**Re: *Initial Engineering Review
Earth Removal Application
Fuller Street Cranberry Bogs and Reservoir
ADE Project #2518.45***

**Subject: MIDDLEBOROUGH - Fuller Street LLC - Earth Removal Permit Application
Fuller Street, Middleborough, MA
Response to Town Department Comments**

Re: Response to Engineering Review
Earth Removal Application
W. L. Byrne Inc.
G.A.F. Engineering Job No. 14-8284

FIGURE 1

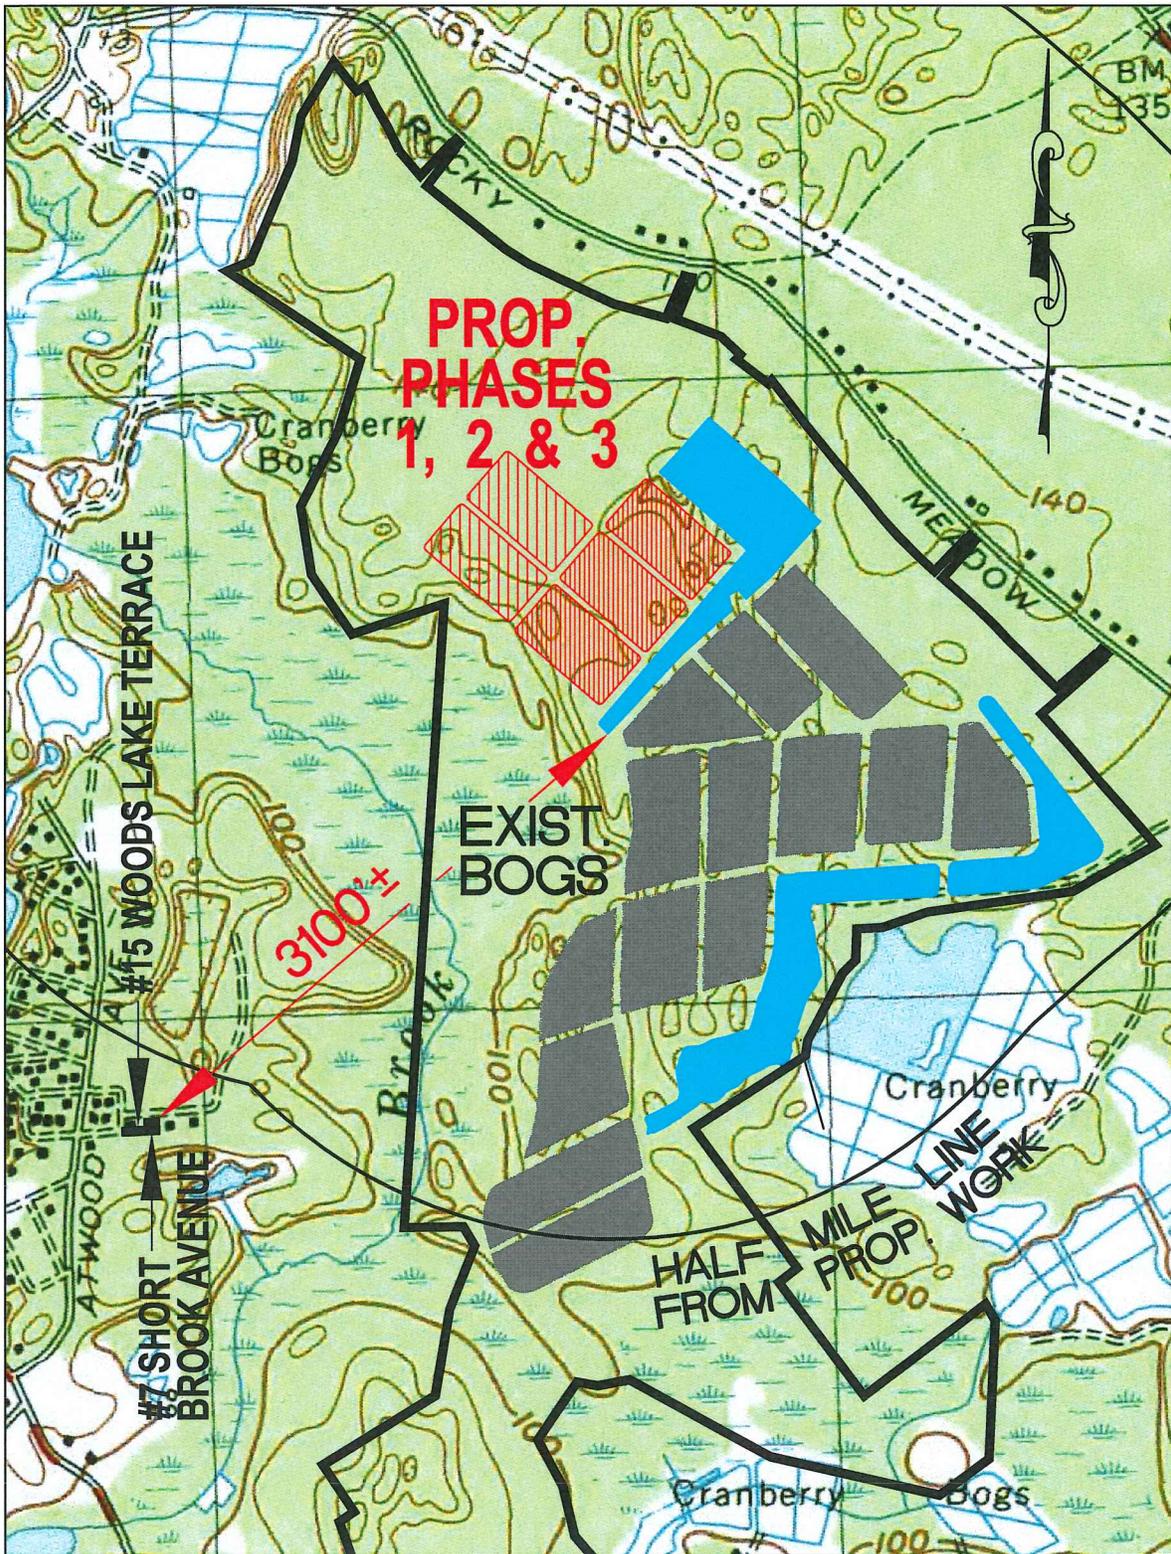
The 15 Woodslake Terrace and 7 Short Brook Avenue properties are located over one half mile feet from the proposed water supply source of the W.L. Byrne cranberry bog project (Refer to Figure 1). The water management system of the W. L. Byrne Cranberry Bog employs complete tailwater recovery where by all water, not used by plant uptake or lost to evapotranspiration, is returned to the water supply reservoir making the water usage virtually non-consumptive.
